TESTIMONY OF MICHAEL A. STOVER DATED JANUARY 25, 2018
In ZC CASE 16-23 Valor Development LLC Square 1499

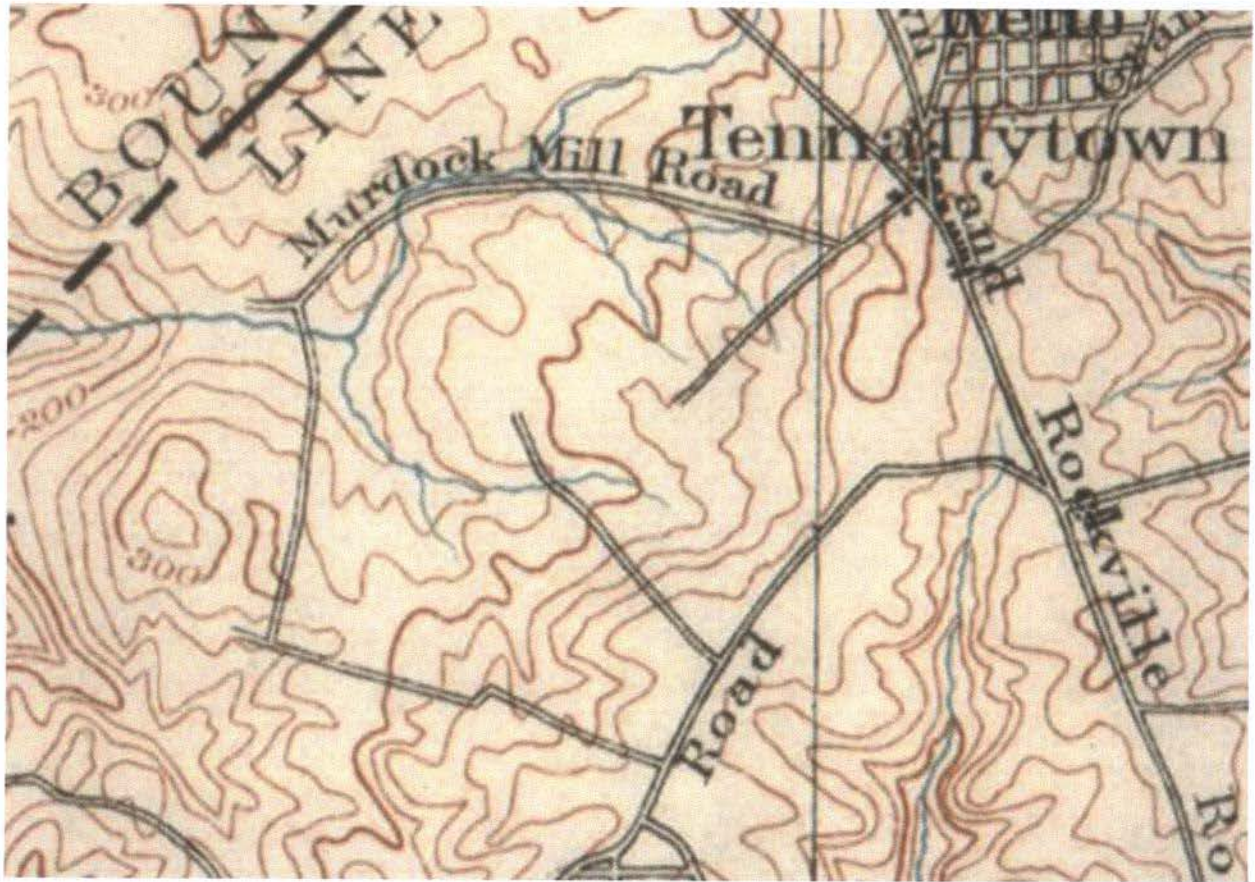
Furthermore, I would like to point out that the Office of Planning has made two serious errors in regard to the points I am making. In the first place, The Ladybird building is not "stepped down" in height along Yuma Street. Perhaps the OP is referring to the building's upper floor setbacks, but these are not **actual** reductions in height. As the Court of Appeals has ruled in the Durant case, such cosmetic features designed to mitigate the **impression** of height do not give the Commission a basis for deeming the building **less high than it actually is**.

Detail from U.S. Geological Survey of the District of Columbia, topographic map, published in 1886, in the Library of Congress

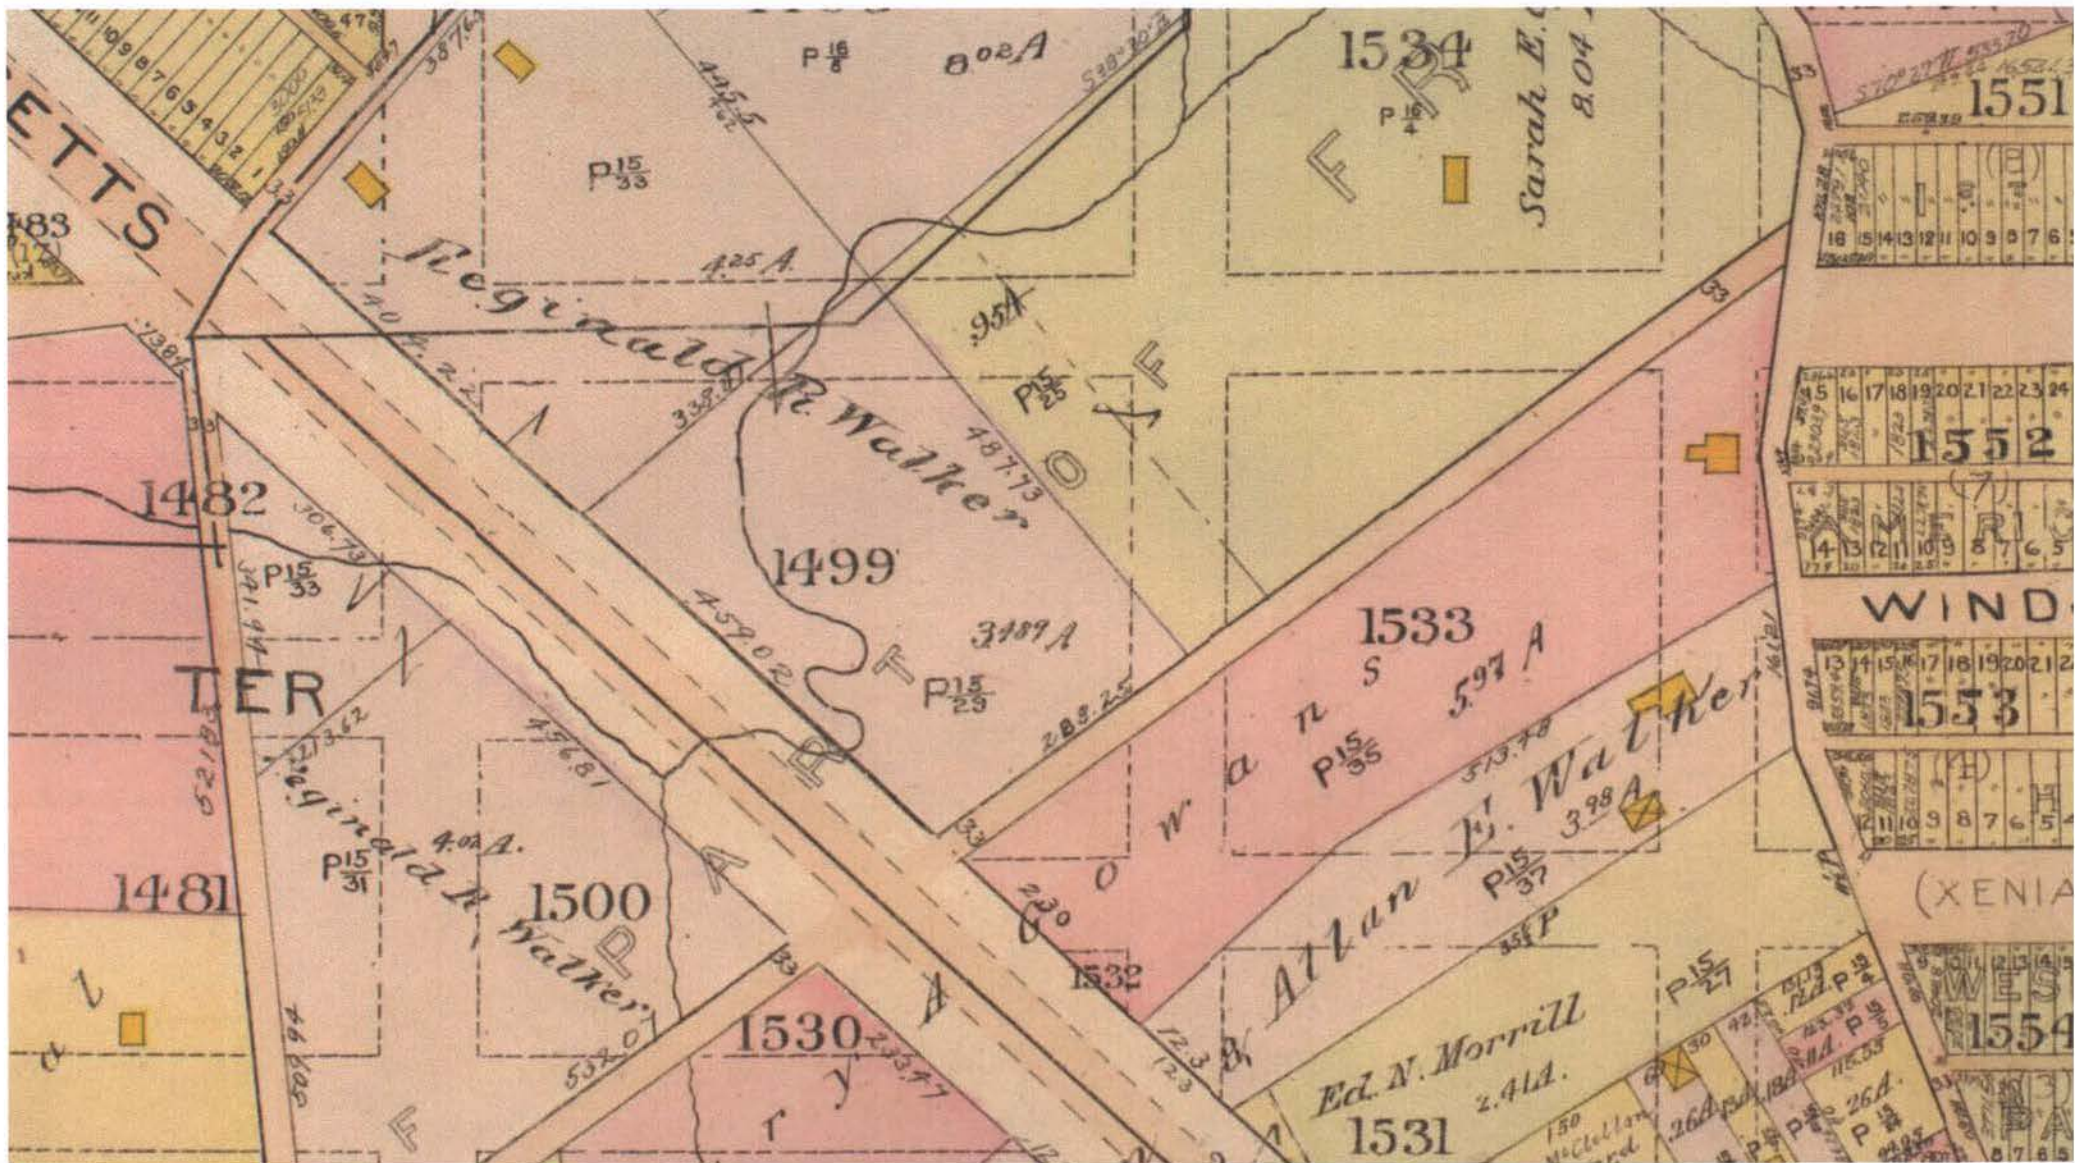
From my observation of the topography, it is clear that the roadbed for 48th Street was leveled across the natural slope by building an artificial embankment on the downhill side, as illustrated by the diagram and photographs in the CRD Response. This conclusion is borne out by reference to the 1886 USGS topographic map (attached), which shows a continuous slope from above 48th Street down to what is now the SuperFresh lot. (You can get your bearings on this map by reference to the 1919 atlas map of D.C., also attached. Both maps show the location of Murdock Mill Creek at the bottom of the slope, which ran across Square 1499 - the SuperFresh site - as indicated on the 1919 map.) As you can see from the photographs, the 48th Street embankment levels the roadbed as well as the adjacent sidewalks and the lawn area with its trees. On the downhill side, the flat top of that embankment extends 24 feet from the 48th Street curb to the retaining wall. Just below that artificial embankment and retaining wall, there is a major excavation to accommodate the lower floor of the parking garage.
